HISTORIC AND DESIGN REVIEW COMMISSION

June 17, 2015

HDRC CASE NO: 2015-234
ADDRESS: 1902 SAN PEDRO AVE
LEGAL DESCRIPTION: NCB 1858 BLK 1 LOT 12 AND 13
ZONING: C2 H
CITY COUNCIL DIST.: 1
DISTRICT: Monte Vista Historic District
APPLICANT: Marcus Guerra
OWNER: Goen Otha Morris
TYPE OF WORK: Exterior alterations
REQUEST:

The applicant is requesting a Certificate of Appropriateness for approval to:

1 FRONT ELEVATION
SCALE: 3/16" = 1'-0"

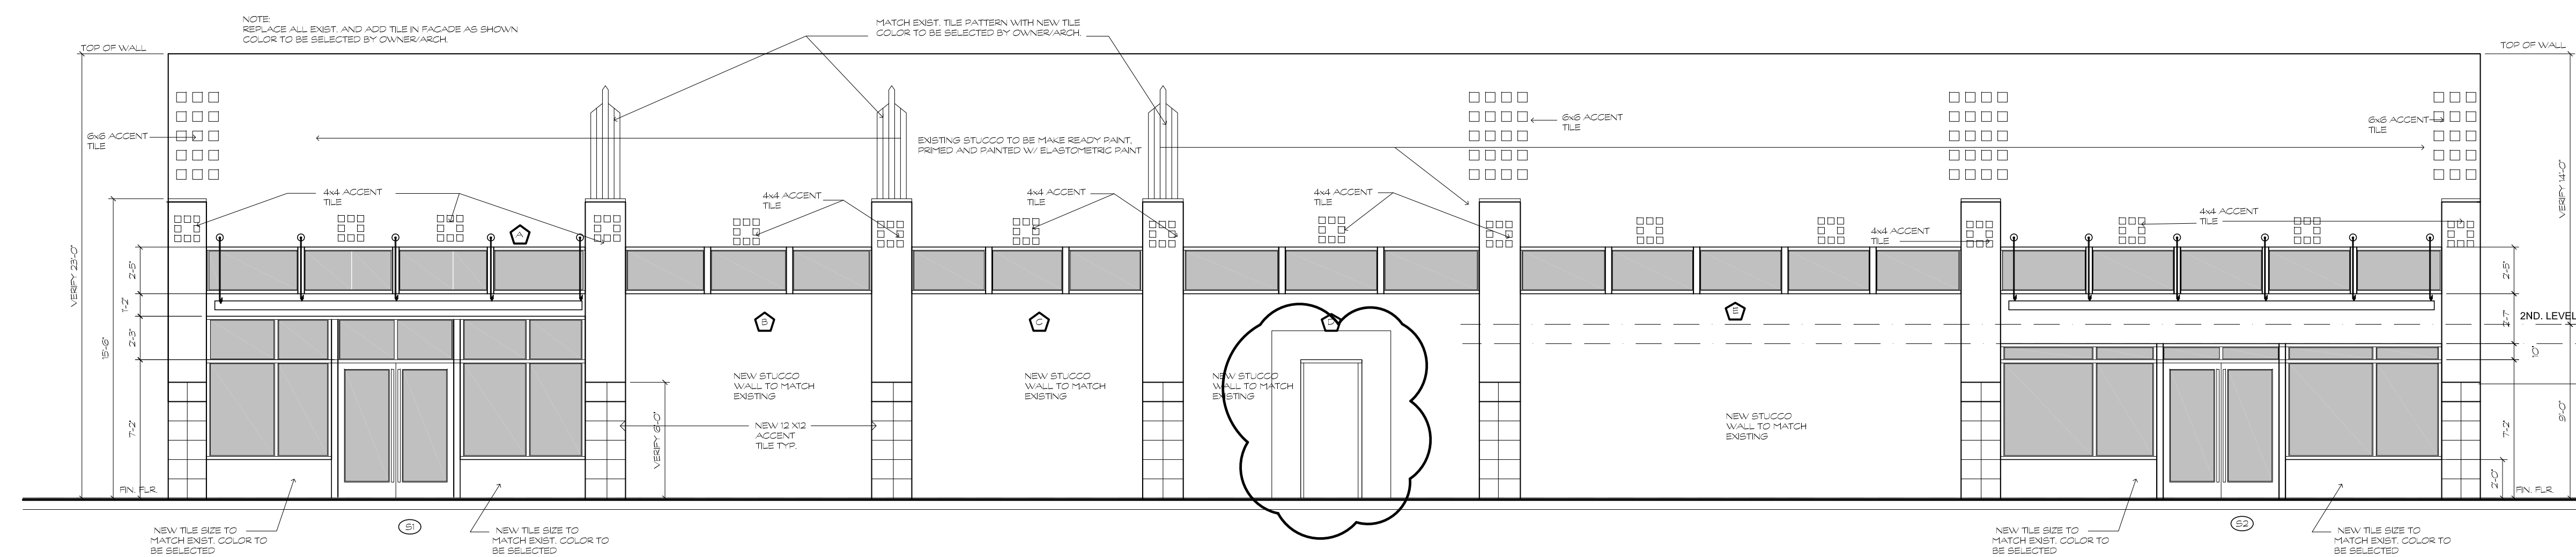
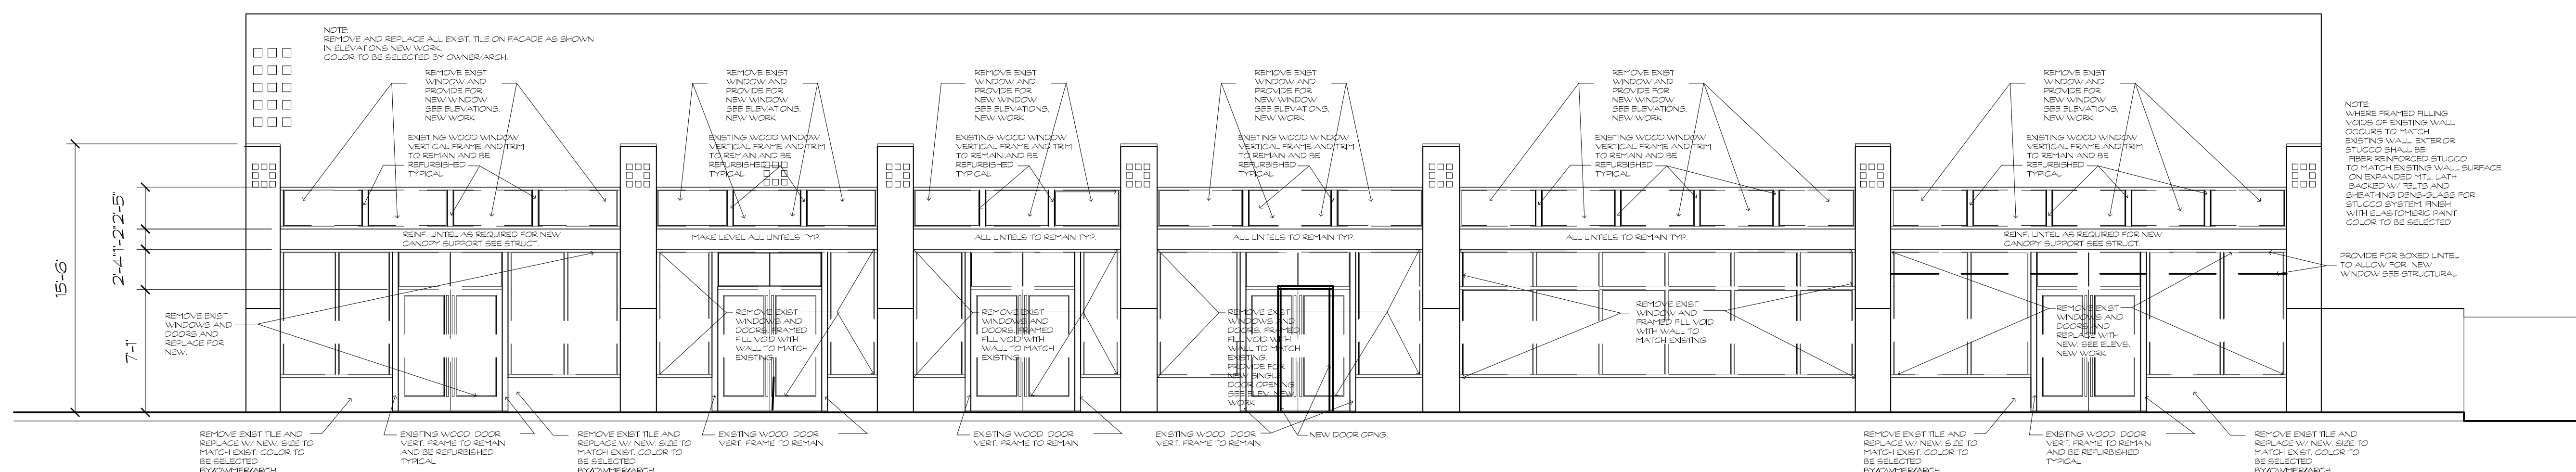
- a. According to the Guidelines for Exterior Maintenance and Alterations, existing door and window openings should be preserved. In addition, filling in historic window or door openings should be avoided. Furthermore, introducing new facade elements that alter or destroy the historic building character, such as altering the size or shape of windows, doors, bulkheads, and transom openings should be avoided. The proposed infill, removal and re-sizing of the existing storefront, door and window openings will drastically change the facades of the building which should be avoided. Although some of the storefront windows have been previously modified, the original openings are intact and should be preserved.

- b. Consistent with the Guidelines for Exterior Maintenance and Alterations, windows should be repaired if possible. When deteriorated beyond repair, windows should be replaced with new windows that match the historic windows in size, type, configuration, material, form, appearance, and detail. Although some of the original storefronts have been modified, enough original material exists to determine the original form, configuration and appearance of the original windows. The proposed aluminum storefront system does not match the original material, form, appearance and detail of the original materials which is not consistent with the guidelines.

- c. As recommended by the Guidelines for Exterior Maintenance and Alterations, historic doors should be preserved. Although some of the original doors have been removed, the existing original doors should be preserved. If deteriorated beyond repair, they should be replaced in kind to match existing in size, type, configuration, material, form, appearance, and detail.

- d. According to the Guidelines for Exterior Maintenance and Alterations, new canopies and awnings should be based on accurate evidence of the original, such as photographs. If no such evidence exists, the design of new canopies and awnings should be based on the architectural style of the building and be proportionate in shape and size to the scale of the building façade to which they will be attached. No historic pictures of the building are available, however Sanborn Maps show the building originally had a canopy that ran along the front façade of the building. Installation of a new canopy is consistent with the guidelines. However, a canopy that ran continuously along the front façade would be more appropriate.

- 1. Staff recommends approval of item 1 as submitted.
- 2. Staff does not recommend approval based on findings a-c. Staff recommends the following:
 - a. Existing window and door openings are preserved.
 - b. Historic windows and doors are repaired. If deteriorated beyond repair they should be replaced in kind to

match existing in size, type, configuration, material, form, appearance, and detail.

- c. Existing size or shape of windows, doors, bulkheads, and transom openings along the front façade is preserved.
3. Staff recommends approval based on finding d with the stipulation that the canopy extends continuously along the front of the building.
